ADDENDUM NO. 3

Reference: New Classroom Building
UVU - Orem, Utah
DFCM Project No. 12192790

ADDENDUM NO. 3
May 22nd, 2013

Utah Valley University Classroom Building
Orem, Utah

Level 2 Area 'A' Finish Plan

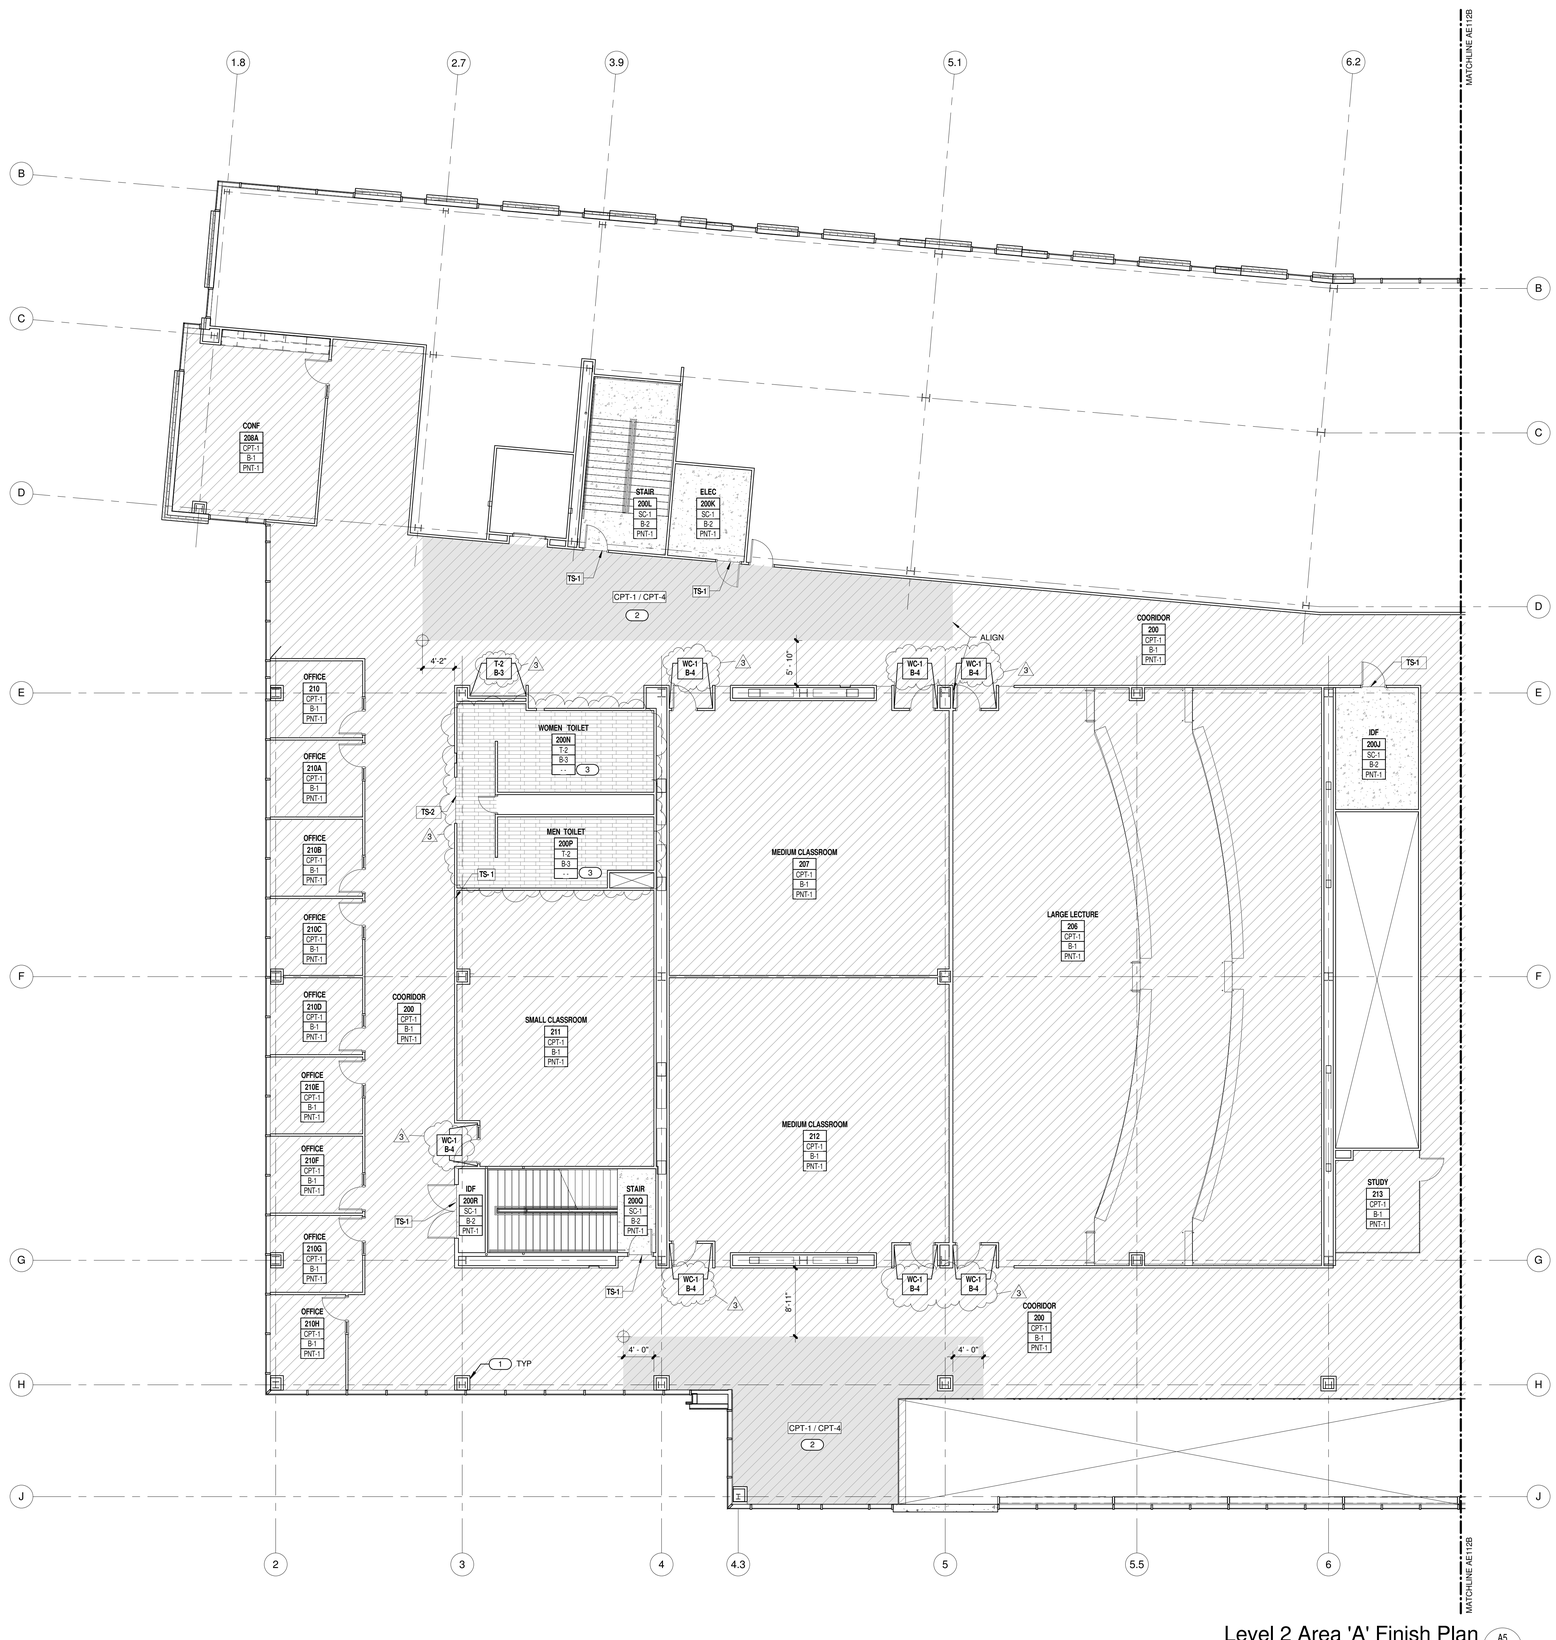
12. Sheet AE112A, Revised finishes and added base to wall & base specific tag for wall and base finish.
13. Sheet AE112B, Revised finishes and added base to wall & base specific tag for wall and base finish.

Level 2 Area 'C' Finish Plan

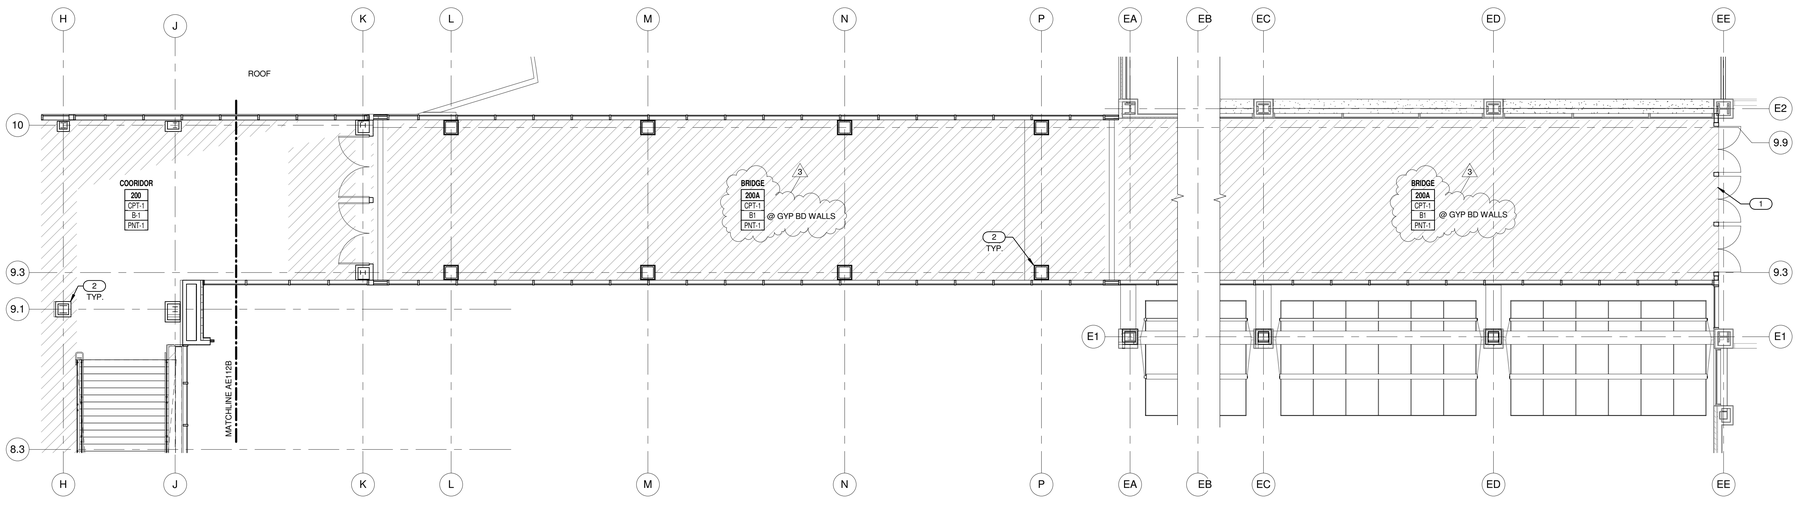
14. Sheet AE112C, Revised finishes and added base to wall & base specific tag for wall and base finish.
15. Sheet AE113A, Revised finishes and added base to wall & base specific tag for wall and base finish.

Level 3 Area 'B' Finish Plan (A5 / AE113B)

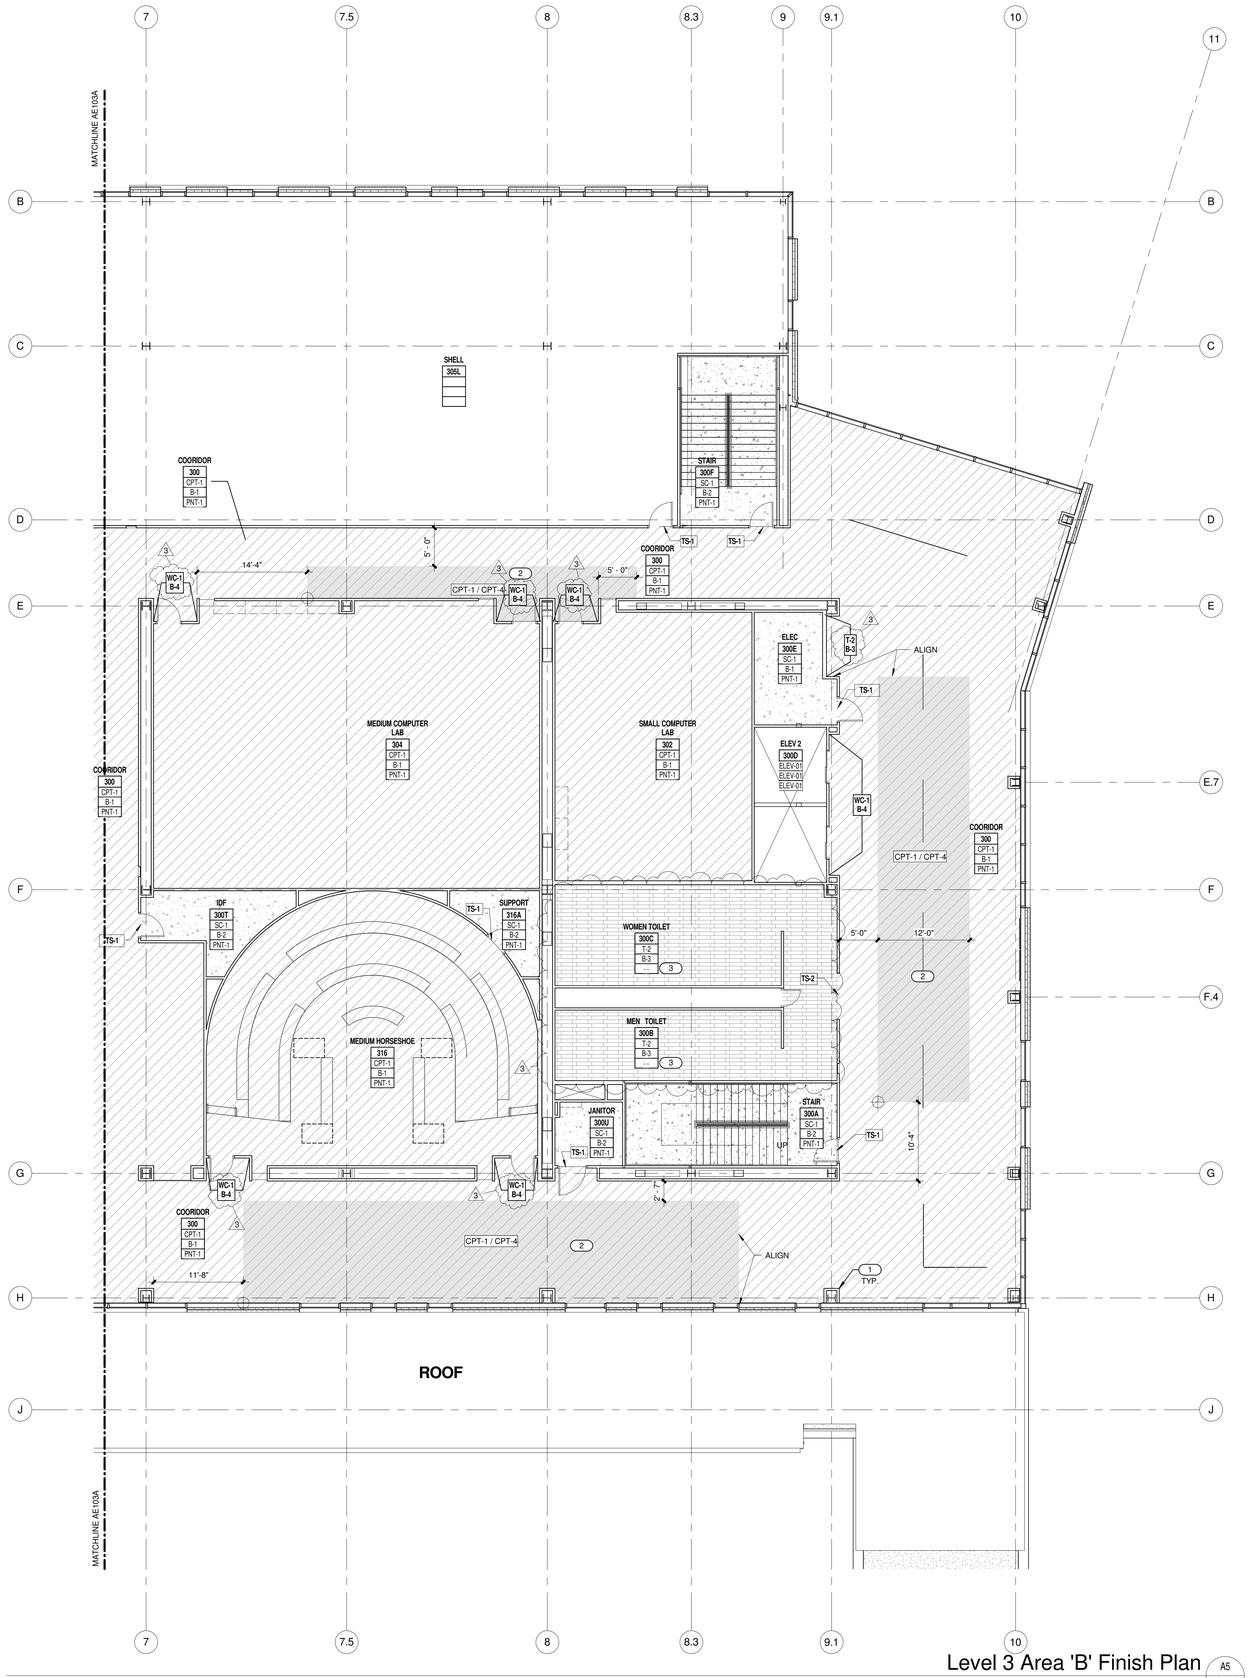
16. Sheet AE113B, Revised finishes and added base to wall & base specific tag for wall and base finish.
17. Sheet AE114A, Revised finishes and added base to wall & base specific tag for wall and base finish.

Level 4 Area 'B' Finish Plan (A5 / AE114B)
1/8" = 1'-0"

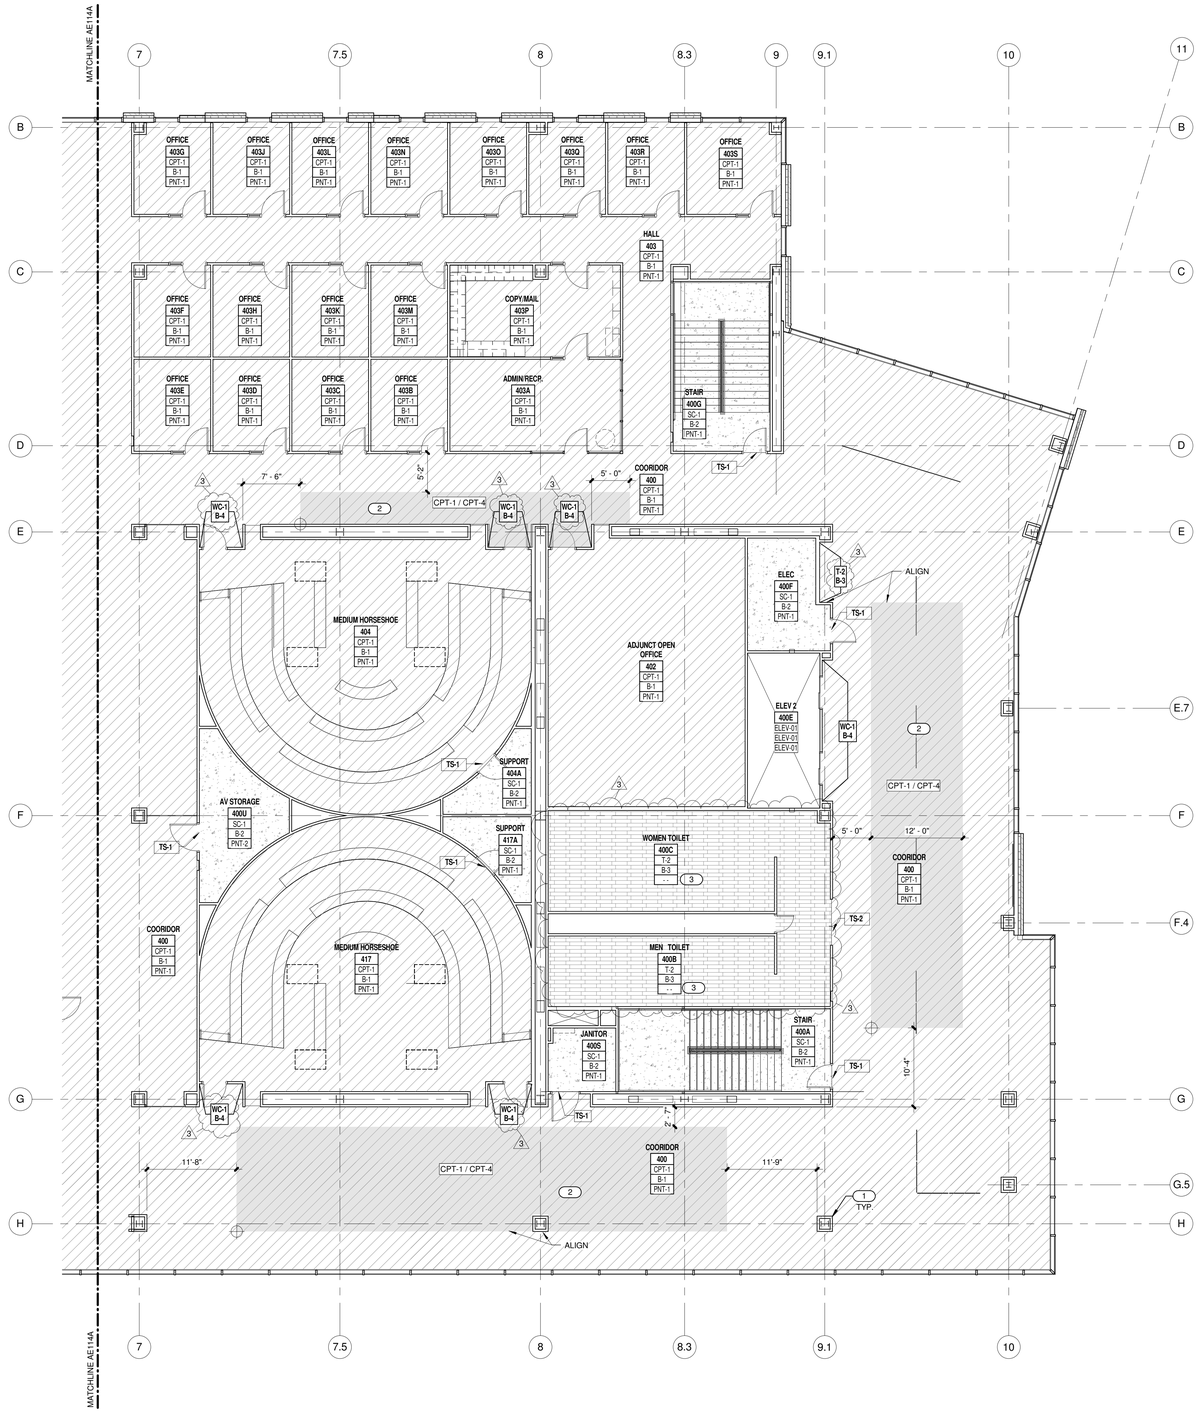
18. Sheet AE114B, Revised finishes and added base to wall & base specific tag for wall and base finish.
19. Sheet AE115A, Revised finishes and added base to wall & base specific tag for wall and base finish

Level 5 Area 'B' Finish Plan (A5 / AE115B)

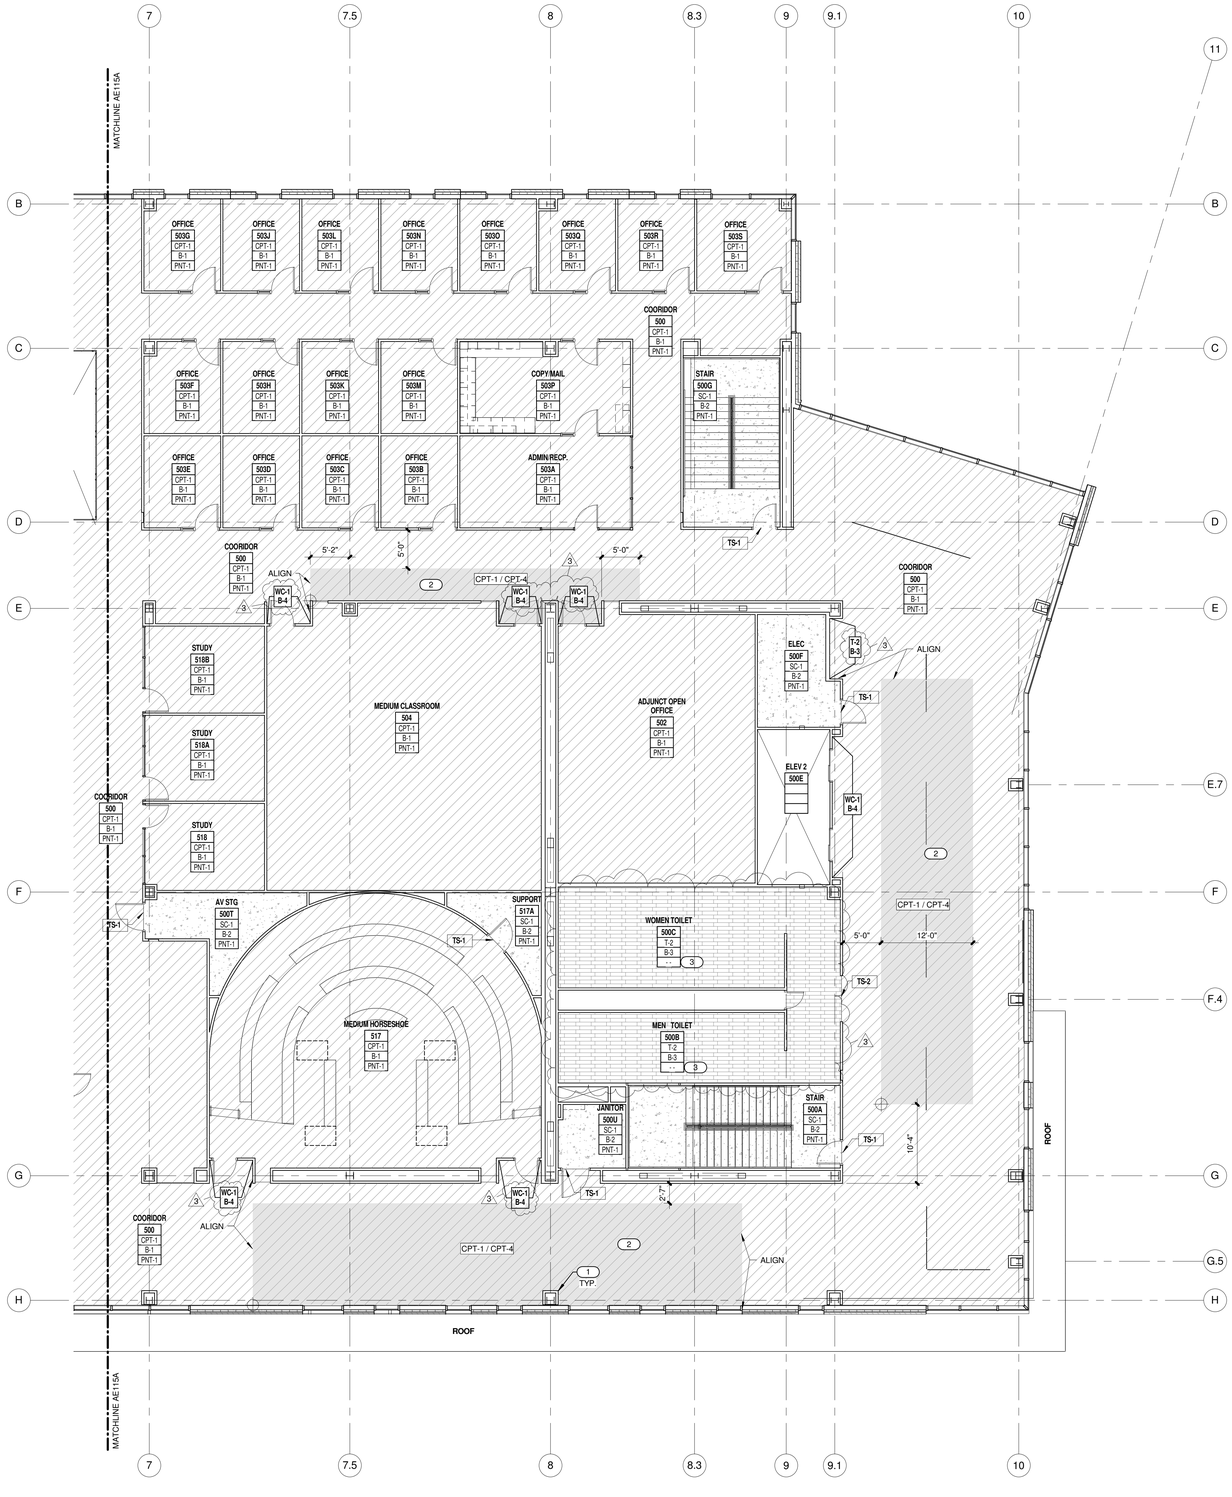
20. Sheet AE115B, Revised finishes and added base to wall & base specific tag for wall and base finish

Level 6 Roof/Penthouse Finish Plan (A5 / AE116)

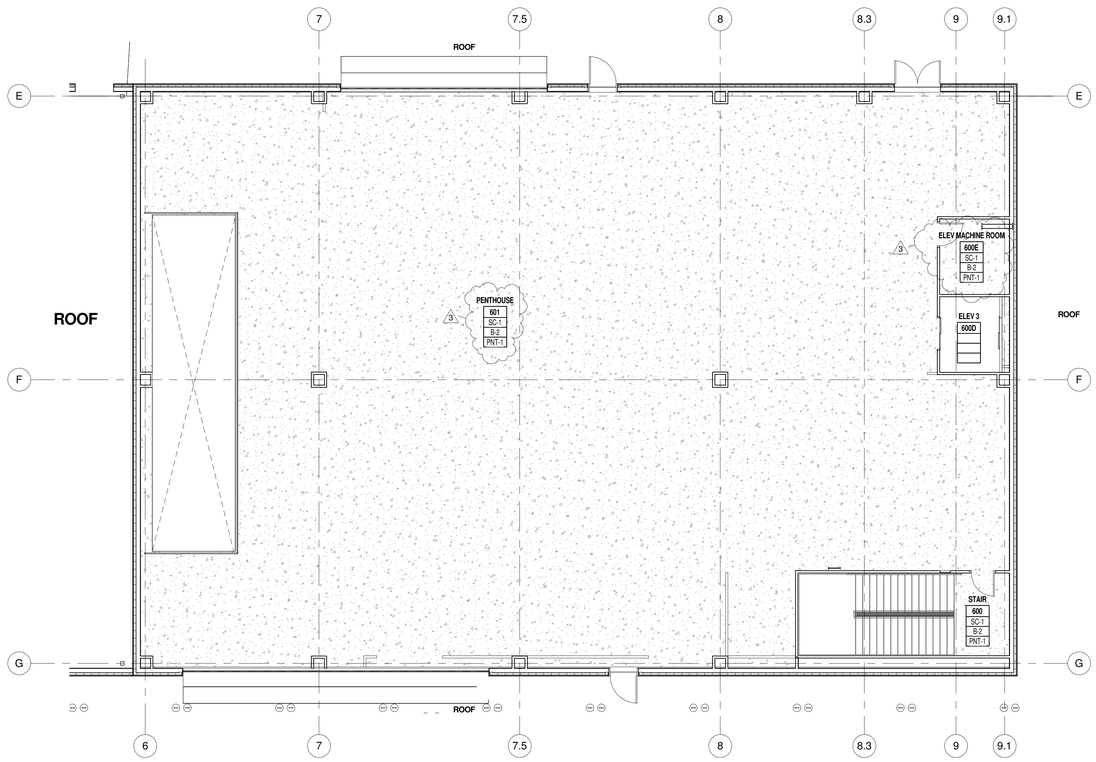
21. Sheet AE116, Revised finishes and added base to wall & base specific tag for wall and base finish
22. For all finish plan sheets, hatch pattern for CP6 and T1, wall and base finish specific tag to be updated to match the attached sheet AE111A.
23. Sheet AE608, Add mechanical louvers to windows type AN. See also item 2 above.
24. Section 096813: Clarification. The Shaw Contract Carpet for this project will be procured and installed from the State of Utah Carpet Contract, #MA2097. Contact Stan Clark from Wall 2 Wall Commercial Floor Coverings for their State Contract pricing at 801-694-4905. The specified Interface Carpet is not on the State contract. Note that not all the specified carpet is available through one manufacturer.

South Elevation D5 AE201
1/16" = 1'-0"

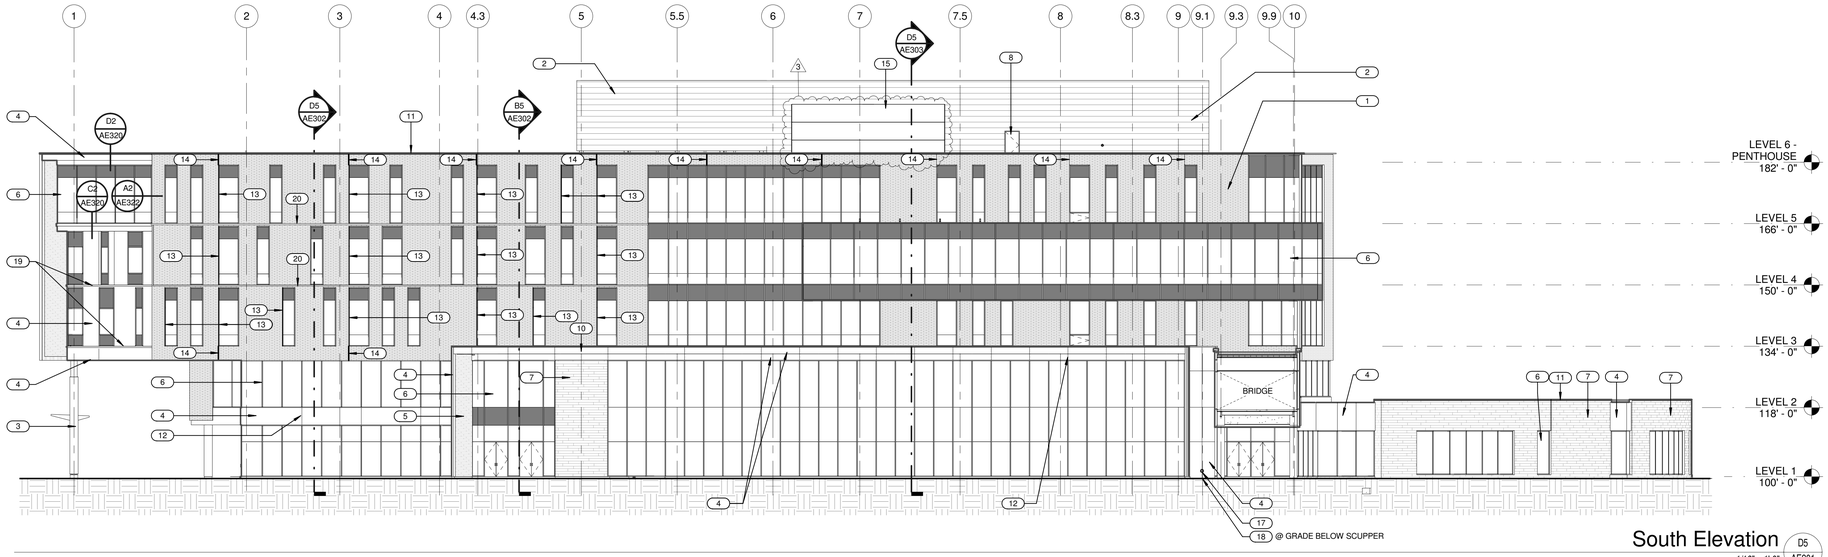
6. Sheet AE106, modified size of storm louvers on grid line E and G to match mechanical, Modified location to match mechanical plans.
7. Sheet D5AE201, size of louver modified to match mechanical louver size as scheduled
